Chatham Forest Subdivision

East Hampton, Connecticut

Eastern Connecticut Environmental Review Team Report

Report #627

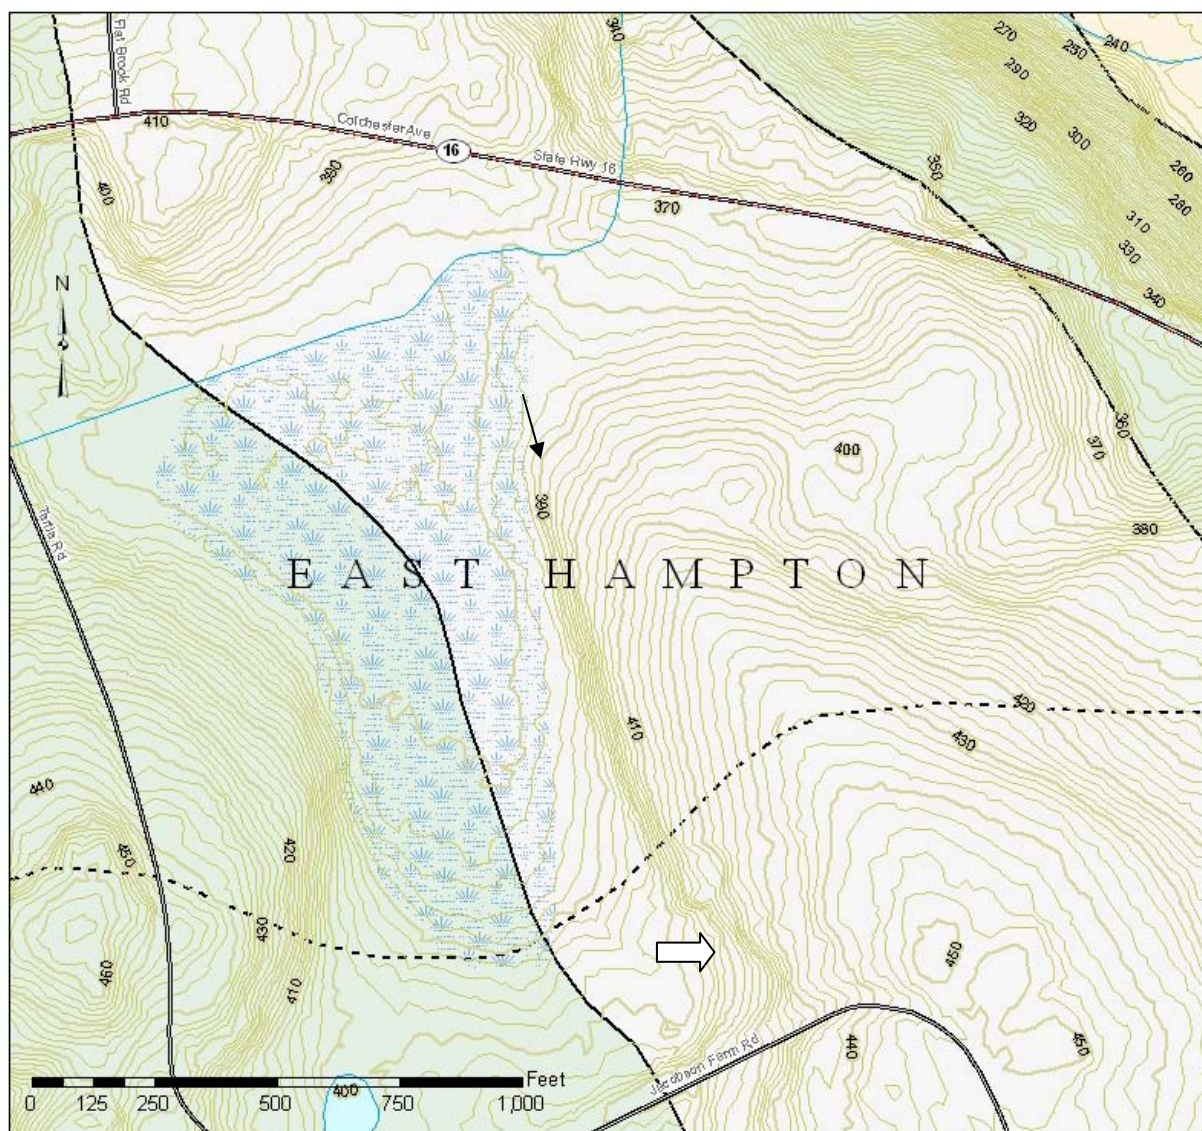
The ~42 acre parcel is occupied by a large wetland area that is flanked both to the west and east by gently to moderately sloped hills (Figure 1). The reviewed subdivision proposes to cluster 15 houses on lots of less than an acre in size along the crest of the eastern most hill (Figure 2A). That hill gently rises southward from State Highway 16 (Colchester Avenue) at an elevation of ~374' to about 440', a rise of 66' over a distance of ~1300'. The maximum elevation of the hilltop south of the parcel is just greater than 450'. The minimum elevation in the wetland is just less than 370'.

current drainage. It is curious that the moderately steep slope continues southward into the bight just north (fat arrow in Figure 1) of Jacobsen Farm Road. The bight has a morphology similar to that formed by erosion of a stream or river meander into the margin of a flood plain. A possible explanation for these two observations is that they were formed by erosion of a melt-water stream. If that is the case, at least 15' of till was removed, substantiating the interpretation of Stone and others, 2005.
